SUBJECT: **R.E. Ginna Nuclear Power Plant**
Docket No. 50-244

Request For Additional Information Regarding Generic Letter 2004-02

Ginna LLC Response to Request for Additional Information
Regarding GL 2004-02, Dated December 4, 2009

Figure 1.2.1 – Ginna Steam Generator and Grating Configuration

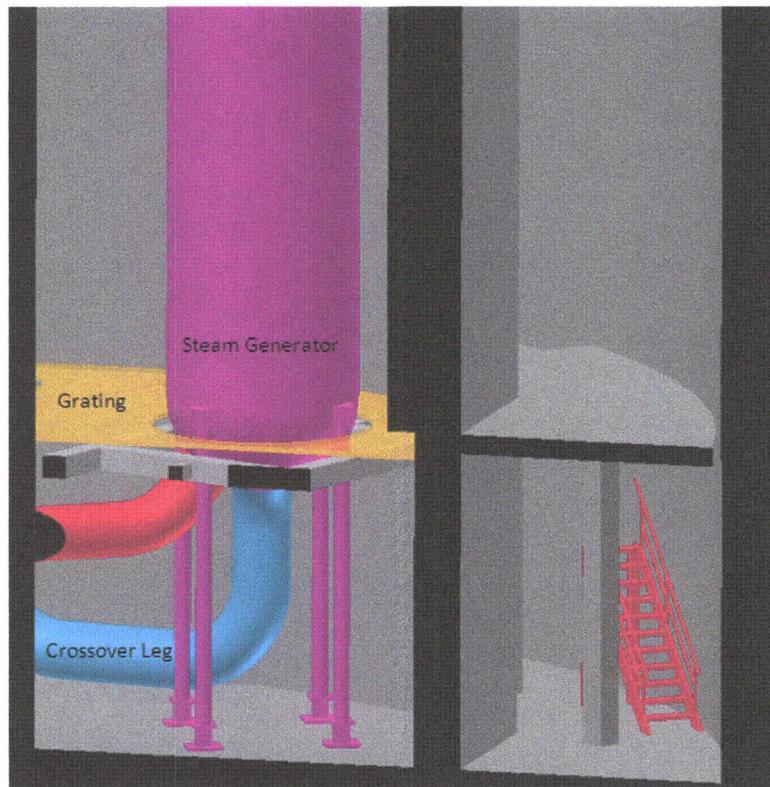
Based on the information provided in the June 2, 2009, supplemental response, it appeared that 3% of small pieces and 37% of large pieces of fibrous debris were assumed to be trapped on gratings during the blowdown phase. Please clarify whether the grating credited with this debris capture is located below postulated break locations, and provide a technical basis (e.g., specific tests from which data was applied) to justify the assumed capture fractions.

There was no credit taken for debris remaining captured on grating below the postulated break locations as there is no grating underneath the break location. The configuration at Ginna is such that the break location is below the grating (on the crossover leg), but the majority of the insulation that could be potentially blown off of the steam generator is above the grating. Thus, no debris held up on grating was credited with being captured below the break location. A cutaway view of a steam generator compartment at Ginna is shown below in Figure 1.2.1.

Figure 1.4.1 – LANL LBLOCA Progression Excerpt

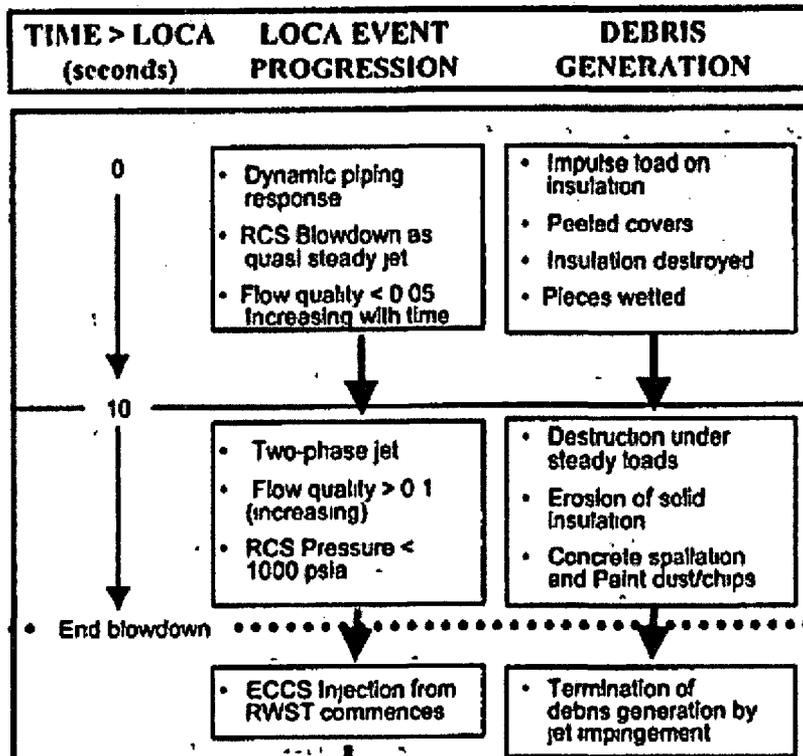
- b) The methodology assumed that the small pieces of fibrous debris would be saturated with water. The basis for this assumption is unclear, given that the fraction of small pieces of fiber that was fragmented and blown to the upper containment would have been impacted with a two-phase jet that had largely flashed to steam before contacting the insulation. Furthermore, the water on the operating deck would largely be spray drainage at cooler temperatures, which does not rapidly penetrate insulation debris due to its viscosity. In addition, on the upper level, the debris pieces would not be fully submerged. Accounting for trapped air in small pieces of fibrous insulation would lead to increased tumbling transport versus the licensee's evaluation, and also to the consideration of the potential for transport via floatation, which did not appear to have been evaluated due to the assumption of the debris being water saturated.

This LANL description suggests that the fluid from a break would be in the form of small droplets that would wet the insulation as it was destroyed. The large break LOCA accident progression scenario is illustrated in Figure 12 of the LANL report. The portion illustrating the first few seconds of the accident sequence associated with debris generation is reproduced in Figure 1.4.1.

Figure 1.8.1 – Reactor cavity area

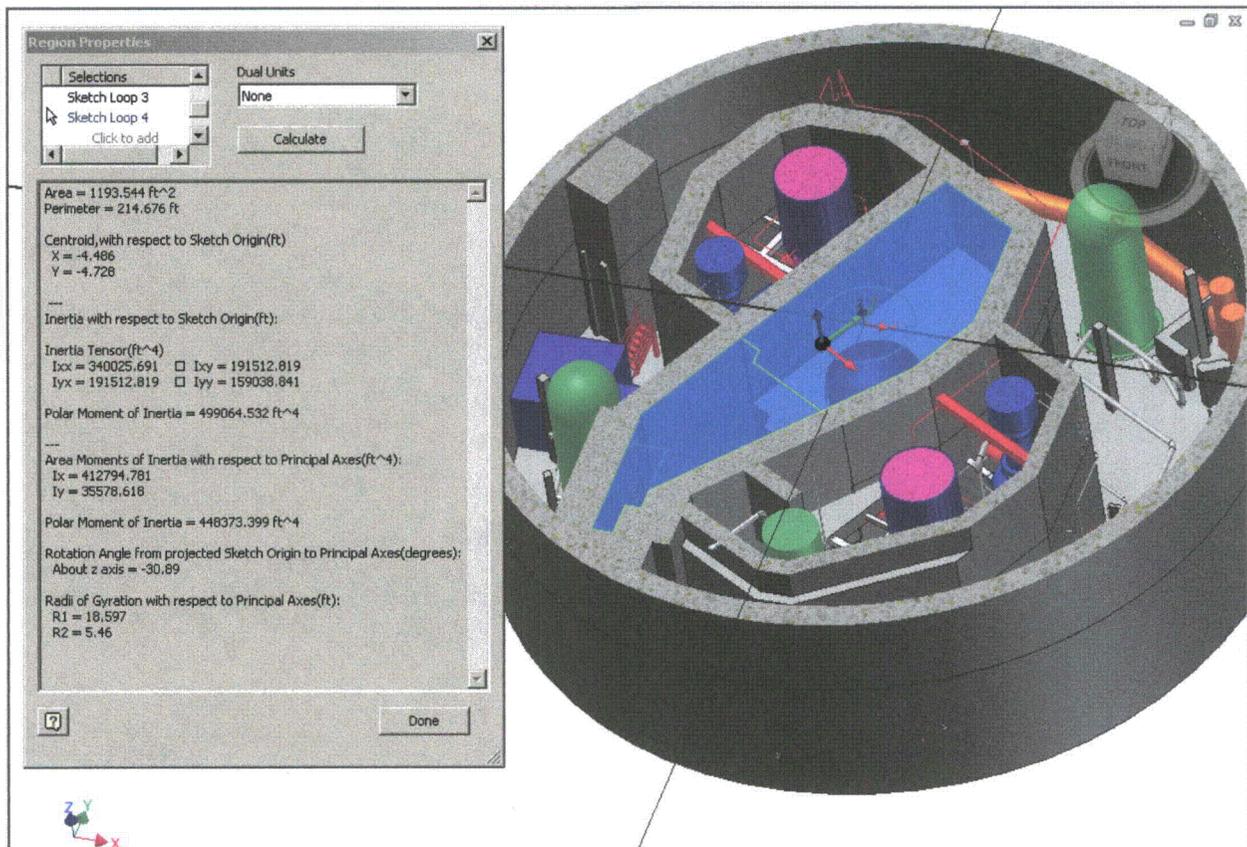
of the containment pool. Please clarify whether filling of the inactive volumes prior to the termination of the containment sprays could occur for any post-LOCA scenarios, resulting in a portion of the debris assumed to wash to the inactive volumes reaching the active containment pool instead.

The maximum volume of spray flow that would be delivered over the 57.56 minutes that the containment spray pumps are running would be 133,172 gallons, which yields an average flow rate of 2,314 gpm [4]. The refueling canal area was calculated to be 1,194 ft² (see Figure 1.8.1) and the cross sectional area of containment was calculated to be 8,669 ft² [4].
